PLEASANT VALLEY WIND PROJECT

PUC Docket Nos. IP6828/WS-09-1197 (Site Permit),
IP6828/CN-09-937 (Certificate of Need)

Re: Pleasant Valley Wind Project
PUC Docket No. IP6828/WS-09-1197

RE: Pleasant Valley Wind Farm LWECS Site Permit Application
[PUC Docket Number: IP-6828/WS-09-1197]

Suess WMA
Marian Marshall WMA
Dodge
Iron Horse Prairie SNA
Olmsted
Schumann WMA
Cap Creek WMA
56
90
Lower
Wild Indigo Prairie SNA
Wild Indigo Prairie SNA
16
218

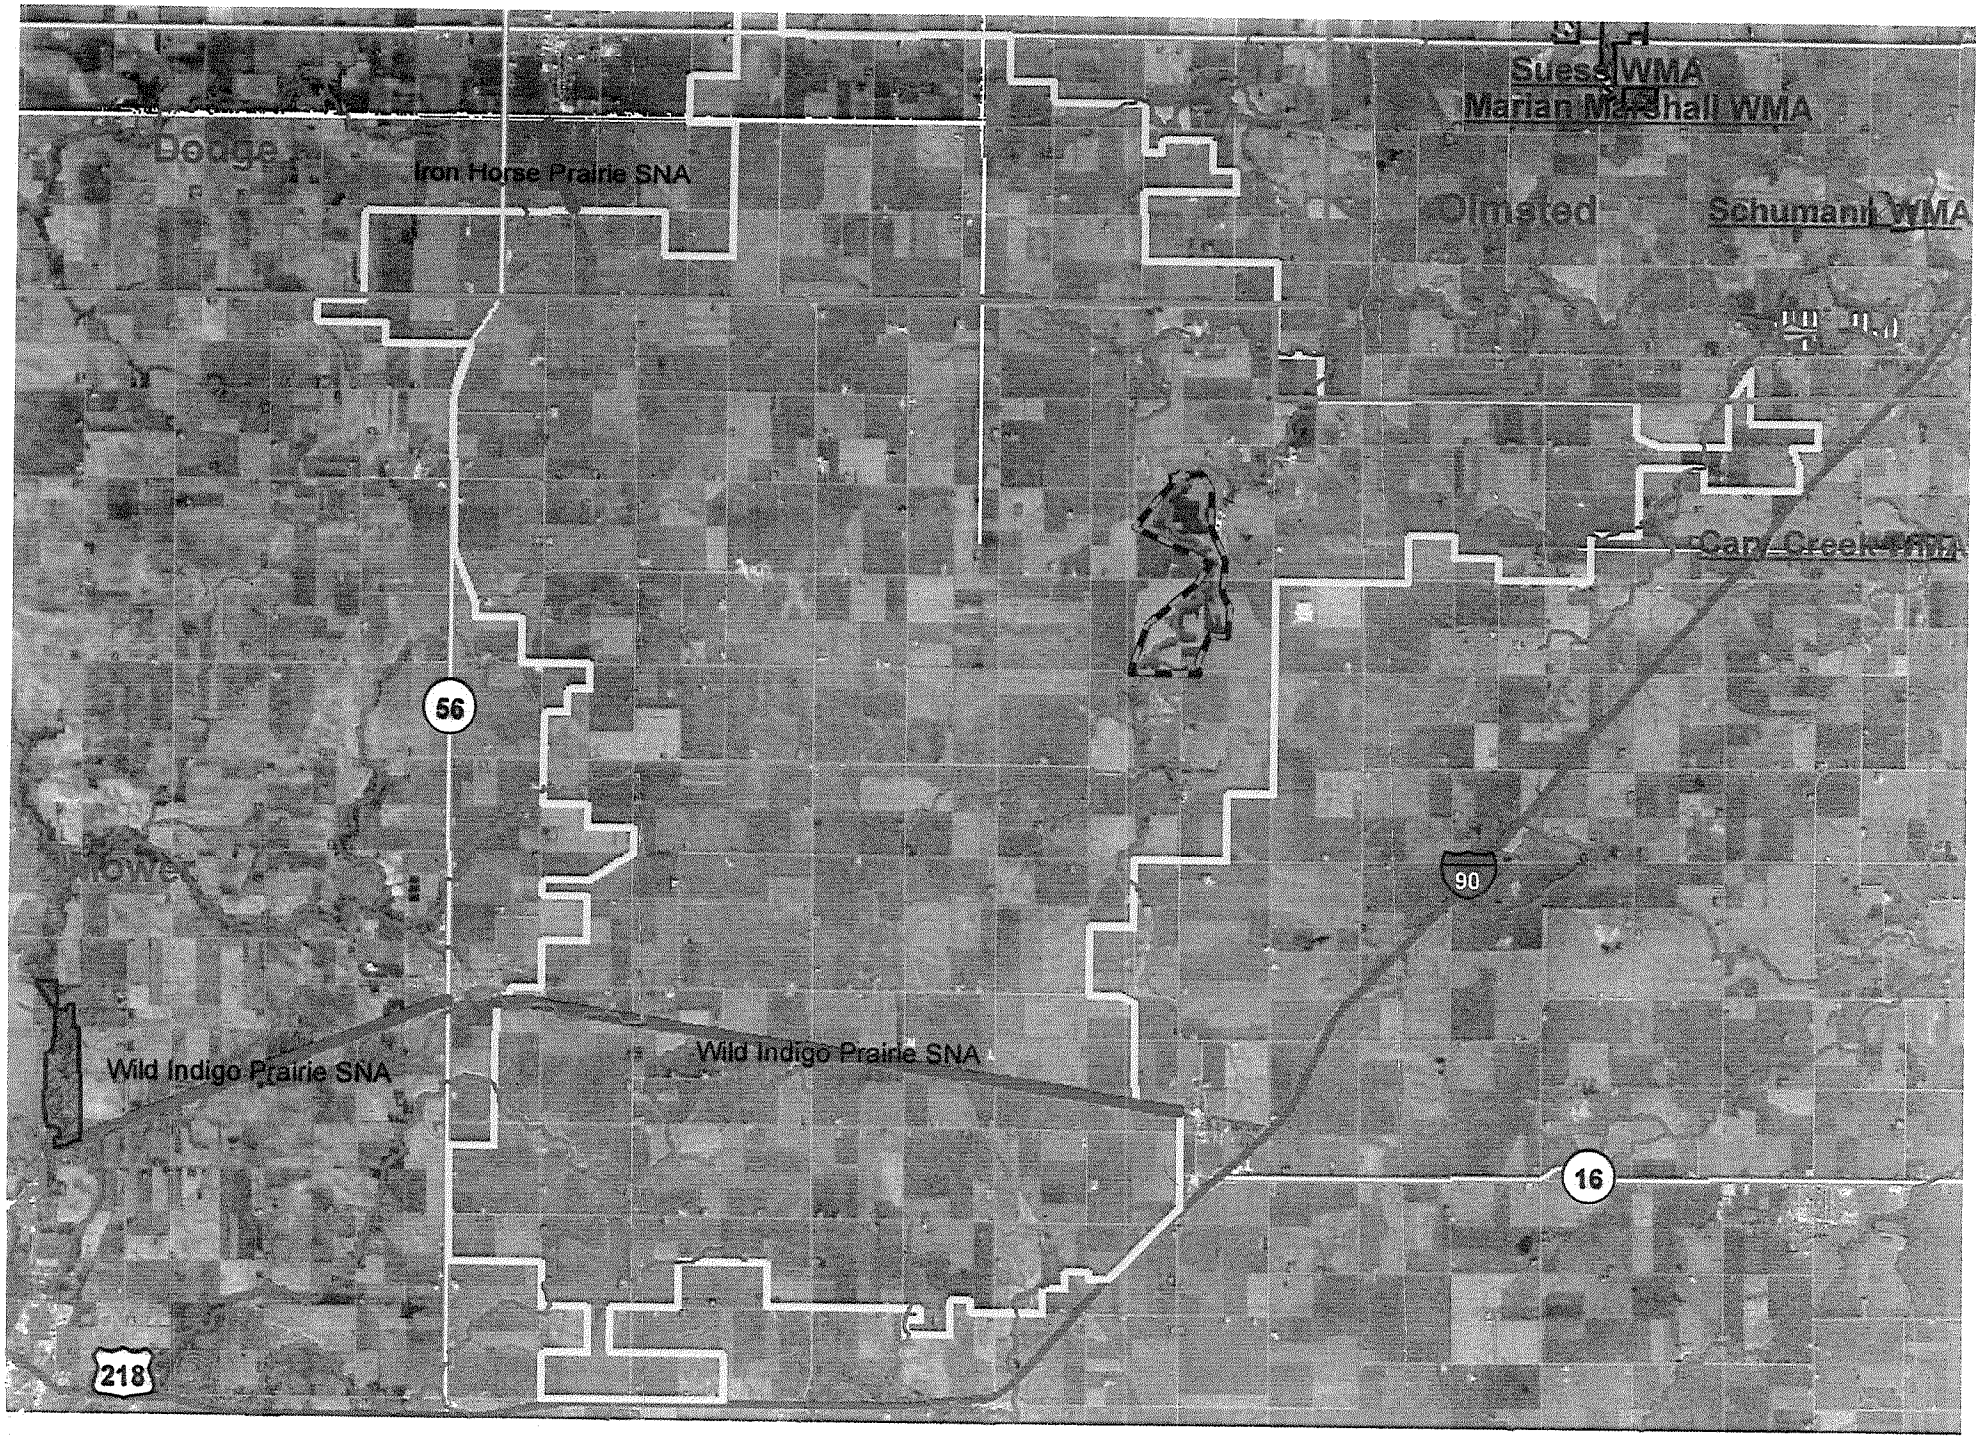
Two DNR managed Scientific & Natural Area's (SNA) are located within and adjacent to the project area boundary that you provided. The DNR recommends that no direct impacts occur to the SNA from tower construction, transmission lines, or road networks associated with the project. The Iron Horse Prairie SNA is located just north of Dodge County CSAH 2 adjacent to the northwest portion of the study area. The DNR recommends a 5 rotor diameter setback from the SNA boundary. The Wild Indigo Prairie SNA cuts across the entire study area from Brownsdale to Dexter, MN. A Unit Trail, managed by the DNR Parks and Trails Division, has been proposed along the old railroad bed along this section of the SNA. The DNR recommends a viewshed analysis be conducted if any infrastructure will be within 5 miles of the SNA boundary. The analysis involves the development of a map or modeling that shows how far the viewshed extends from the SNA and what wind farm infrastructure would be seen from the SNA. The DNR recommended setback from the Wild Indigo Prairie SNA will be determined based on the viewshed analysis. SNA boundaries can be downloaded from the DNR Data Deli (http://deli.dnr.state.mn.us/).

The DNR recommends a 600 foot buffer be placed from the edge of the forested habitat that is associated with the stream as indicated on the attached map (green and black boundary). The buffer has been recommended in order to reduce potential avian and bat mortality and wildlife avoidance that may occur if the turbines are constructed in close proximity to the existing stream and forest habitat complex.
